Planning Commission Minutes
February 22, 2024

(SPUD-1593) Application by Lilyfield Inc. to rezone 1841 Exchange Avenue from R-1 Single-Family Residential, C-3 Community Commercial, C-4 General Commercial, and SRODD Scenic River Overlay Design Districts to SPUD-1593 Simplified Planned Unit Development and SRODD Scenic River Overlay Design Districts. Ward 6.

STAFF REPORT

Agenda Item VII.A.
Case No. SPUD-01593
Property Address 1841 Exchange Ave
Applicant Name Dean Koleada, Civil & Environmental Consultants Inc.
for Holly Towers, Lilyfield Inc.
4700 Gaillardia Pkwy, Ste 101
Oklahoma City, OK 73142
District SRODD/Stockyards River District/R-1 Single-Family Residential
District, C-3 Community Commercial District, and C-4 General
Commercial District

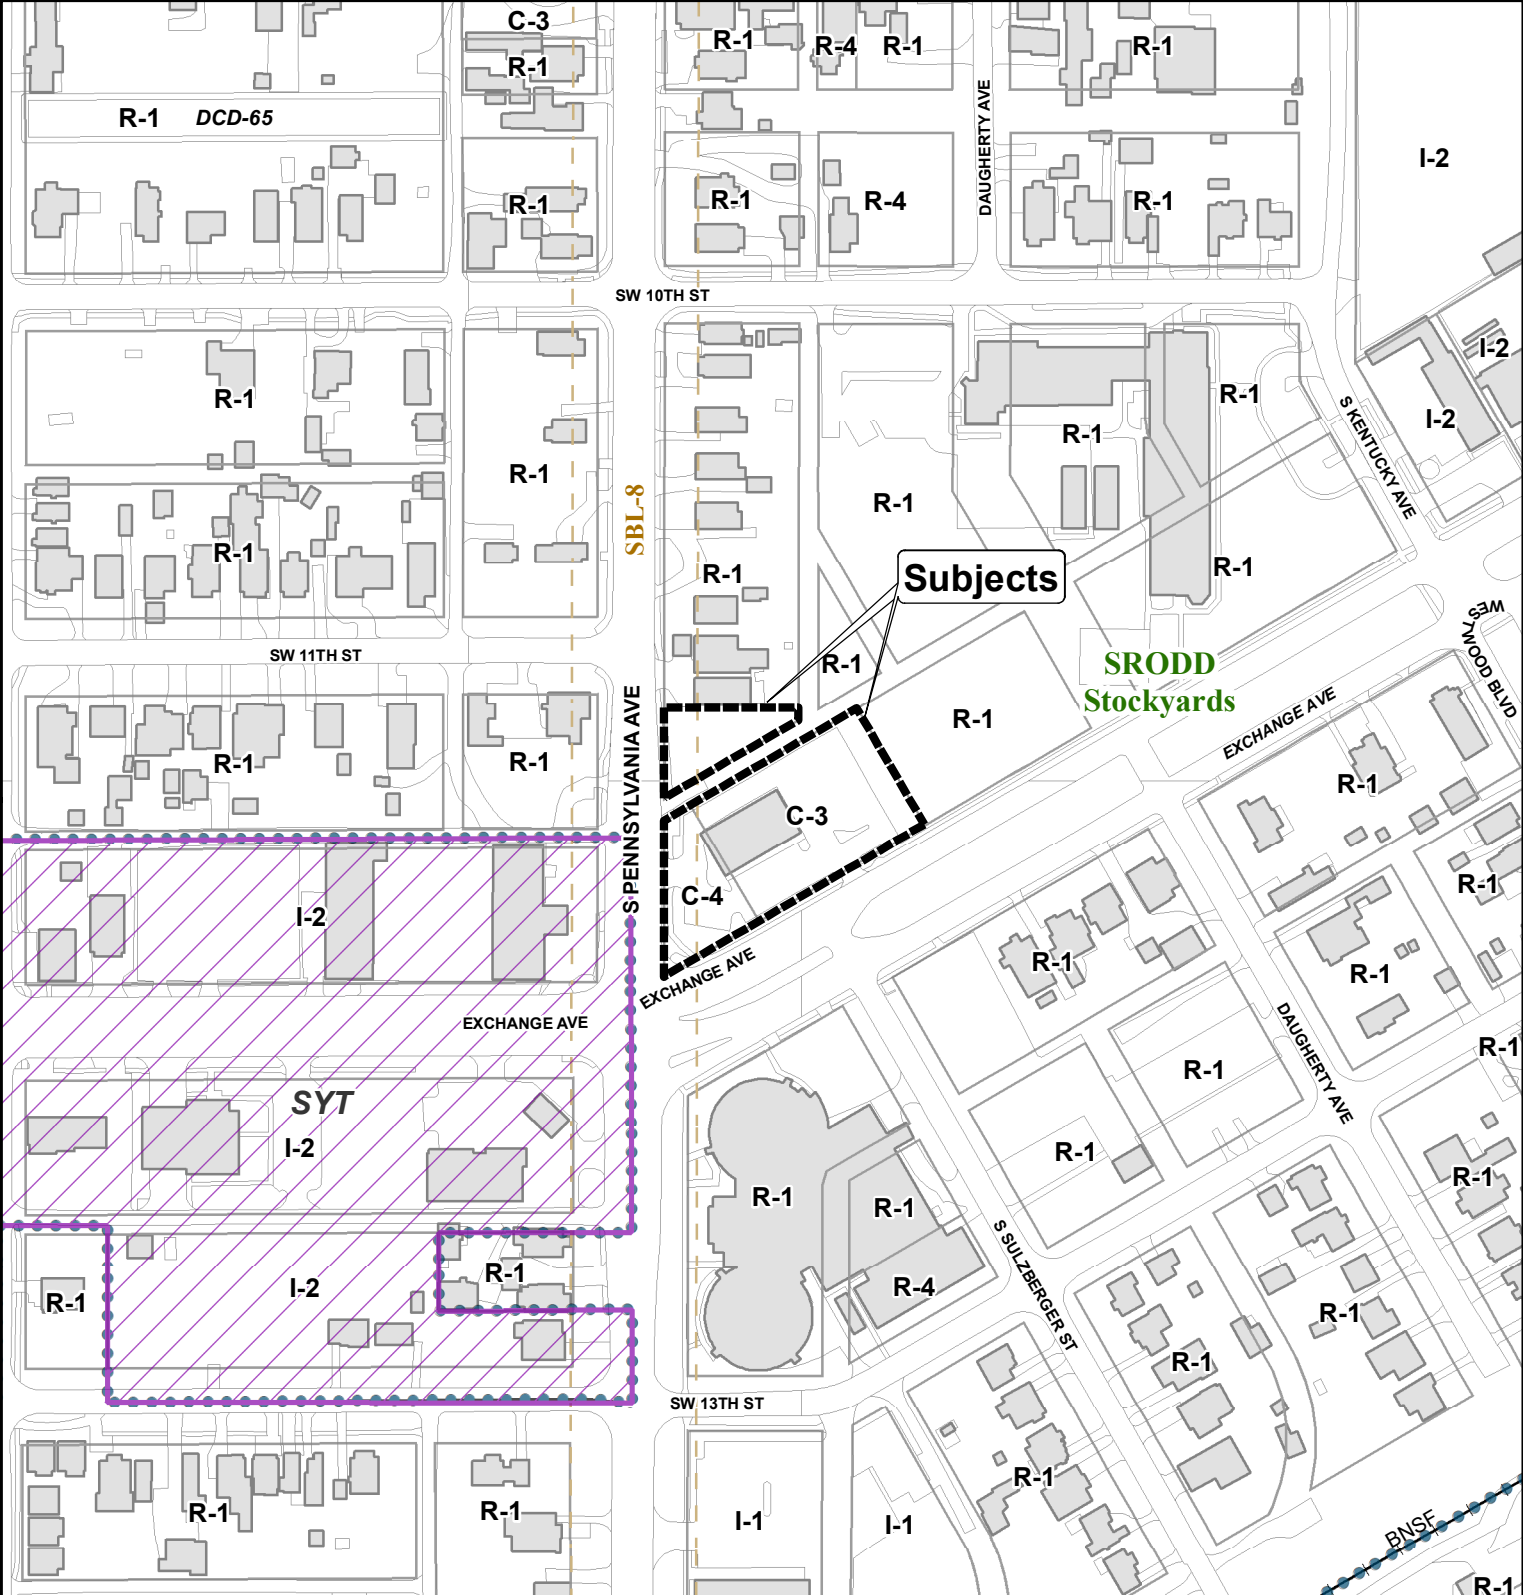
- c) **Re: Proposed alley closure/vacation**
- 1) Description: The applicant has indicated the desire to close the alley with the City of OKC and vacate same in District Court. To

date, the required CE application has not been submitted, although the Site Plan submitted reflects the alley being vacated.

- 2) Considerations: The Site Plan depicts the current alley right-of-way being utilized for the driveway, parking spaces, and landscaping (no specifics shown at this time). The alley contains a City public sewer line and an OG+E overhead electric line. The location of the power poles for this overhead electric line are not clearly depicted on the Site Plan. These power poles will have to be located in a landscape island to protect vehicles. The attached marked-up Site Plan shows the alley right-of-way the applicant will be requesting to be closed and vacated.

Staff is concerned about a closure of the alley in this location because of the impact on connecting alleys in this area. The subject east/west alley has several north/south alleys that extend northward from it. The issues for closure of the subject alley will be discussed at the time the required application is submitted. It is possible that modifications to the parking lot/site layout will be required if the closure is not approved.

C200

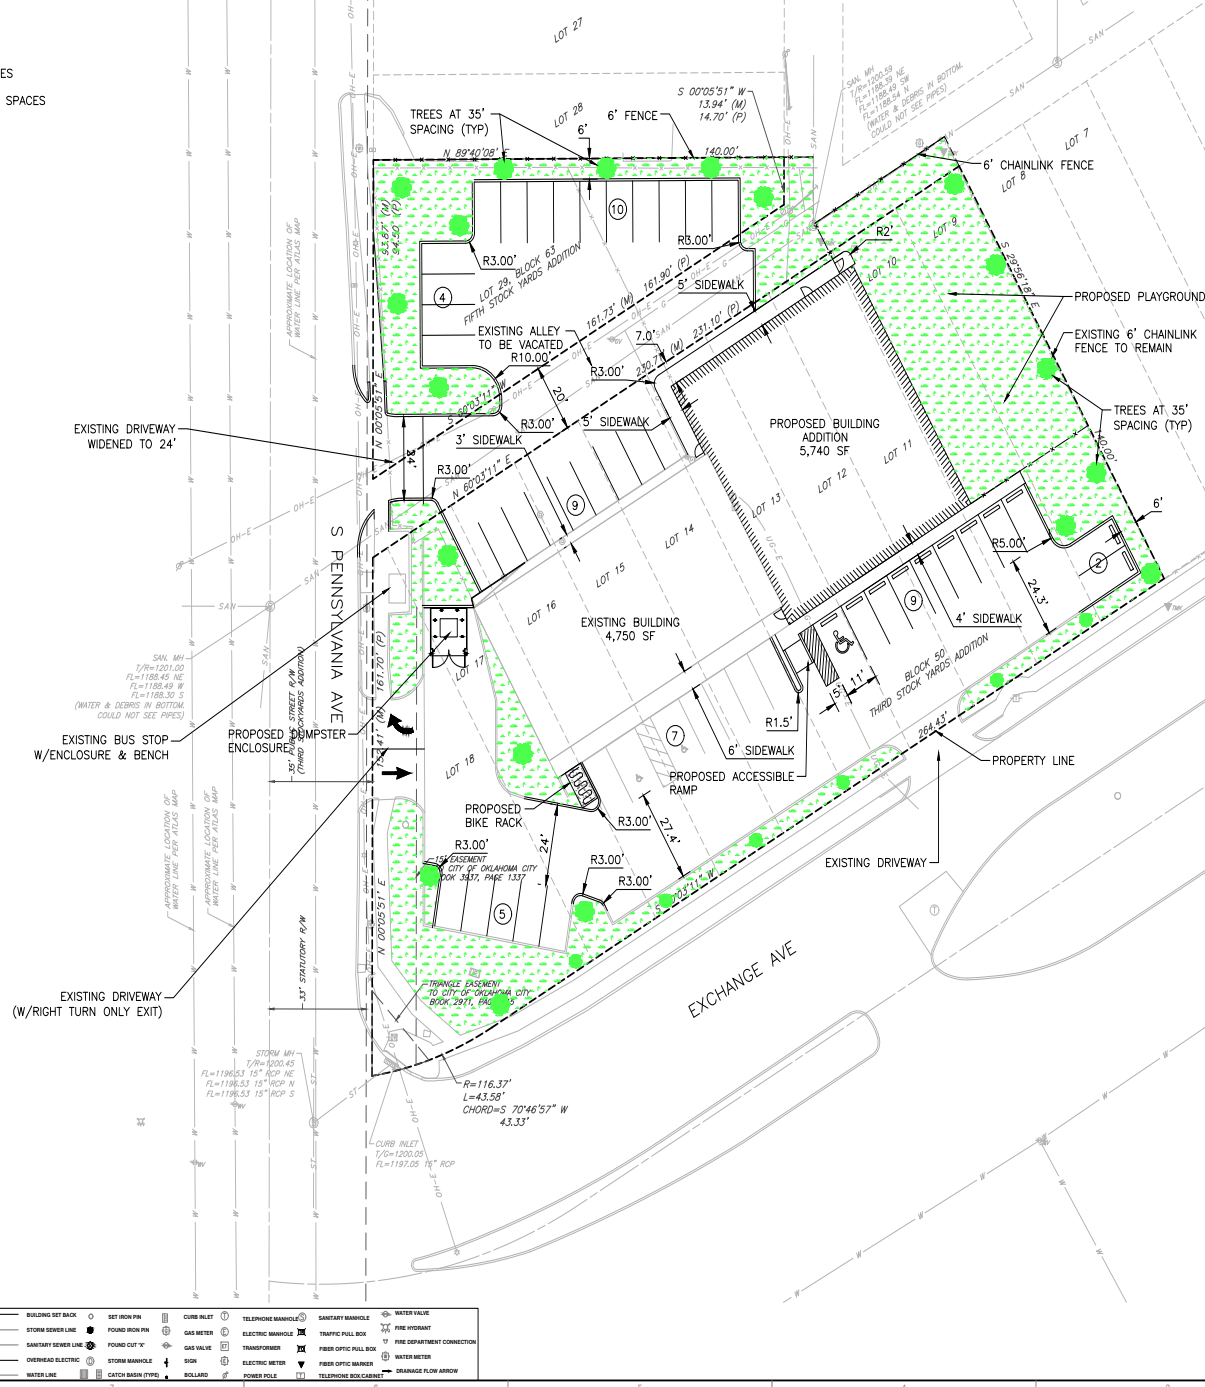
The SPUD proposes to maintain one existing access on S Pennsylvania Avenue and one on Exchange Avenue. It proposes to add a second access on S Pennsylvania Avenue at the location of a platted unimproved alley. Current code allows two 30-foot accesses per "frontage." However, a new bus shelter exists north of the present S Pennsylvania driveway, which would result in a bus stop between the two proposed drives. Plan conformance for automobile connectivity at this major intersection would be increased if the alley were improved for access and the existing driveway closed. This would alleviate potential conflicts with vehicles turning into one of the two drives, and the bus stopping between the two drives. Meeting this goal is complicated, however, by existing power poles in

the currently undeveloped alleyway. Also, the southern drive is shown to serve as an exit point for the trash hauler.

- 1) Description: The site plan provided with the SPUD application does not depict landscaping for the site.
- 2) Reference: §13500.5.J.(2) Landscaping and Screening Regulations.
“(a) *Landscaping.*
 1. *All development shall comply with Article XI, Landscaping and Screening Regulations, with the following exceptions. If a conflict exists, this article shall control:”*
 - “2. *In addition to meeting the City's Landscape Requirements as set forth in Article XI, the following regulations shall apply:*
 - i. *Street trees (minimum 2: caliper) shall be required for all types of development within the SRODD and shall be spaced a maximum of 40 feet on center, however, where insufficient right-of-way exists to accommodate the required sidewalk and five-foot buffer, street trees shall not be required. A revocable permit is required for any landscaping within the public rights-of-*

- 3) Considerations: As currently proposed, the Master Development Statement (MDS) for this SPUD requires this site to meet both the SRODD and City of Oklahoma City's Landscaping regulations. Referenced above is the required landscaping section from the SRODD regulations, which includes street trees, and the required landscaping for parking lots section from Article XI. Landscaping and Screening Regulations from Chapter 59 - Zoning and Planning Code. The site plan submitted with the Certificate of Approval application will be reviewed in accordance with the adopted SPUD. It is possible that modifications to the parking lot as currently illustrated could be required to comply with these regulations.
